MILITARY SPECIFICATION

SWITCH, INERTIA, MARK 104 MOD 1

(For Torpedo Mark 46 Mods 0 through 5)

This amendment forms a part of Military Specification MIL-S-81031B(OS) of 18 December 1967, and is approved for use within the Naval Sea Systems Command, Department of the Navy and is available for use by all Departments and Agencies of the Department of Defense.

FIGURE 3. SENSITIVITY AND CONTACT RESISTANCE TEST CIRCUIT
(10 VOLT OPEN SWITCH POTENTIAL)

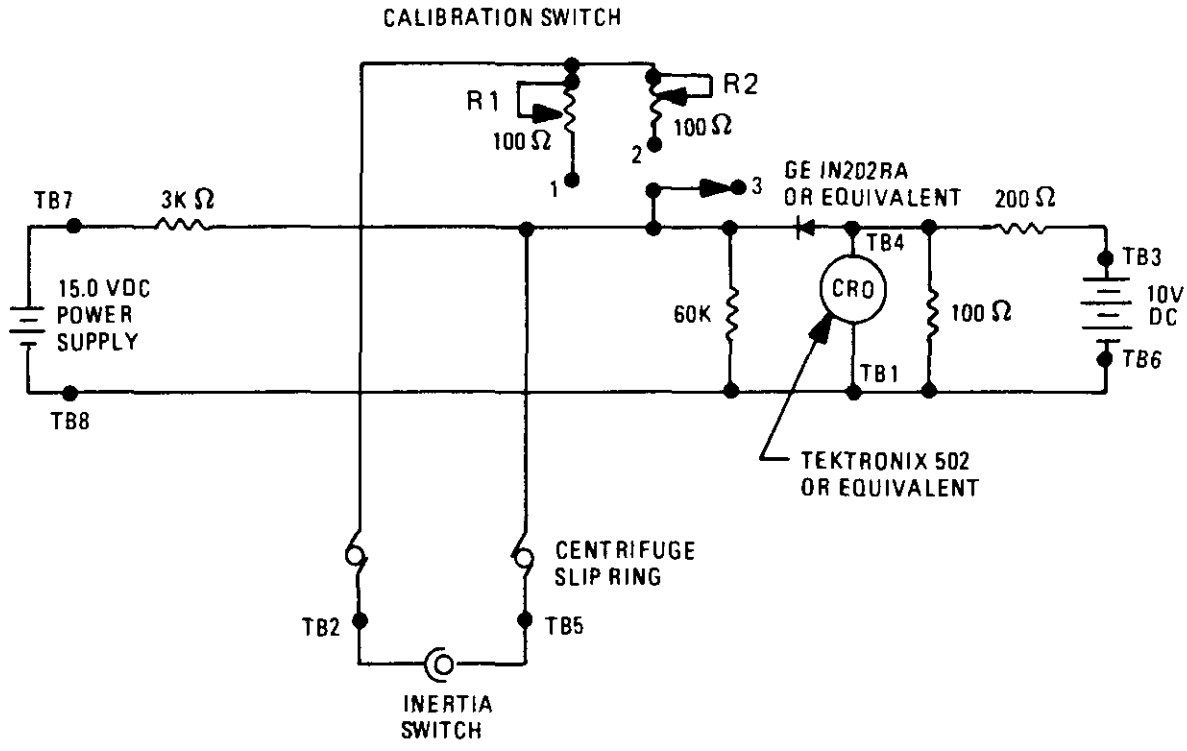
FIGURE 3, delete and substitute:
